OICA proposal for Electrical Safety Post Crash: comparison between previous and new proposal

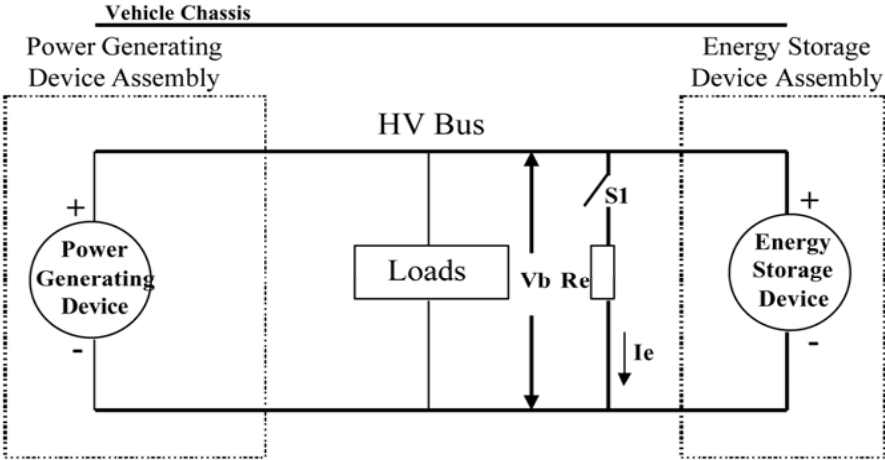
Paragraph	ELSA Draft 080724	OICA draft for ELSA 081012	OICA Comment
	Not more than 5.0 liters of electrolyte from propulsion batteries shall spill outside the passenger compartment, and no visible trace of electrolyte shall spill into the passenger compartment. Spillage is measured from the time the vehicle ceases motion after a barrier impact test until 30 minutes thereafter, and throughout any static rollover after a barrier impact test.]	Not more than 5.0 liters of electrolyte from propulsion batteries shall spill outside the passenger compartment, and no visible trace of electrolyte shall spill into the passenger compartment, within 30min.after a barrier impact test. compliance may be demonstrated by test or analysis.
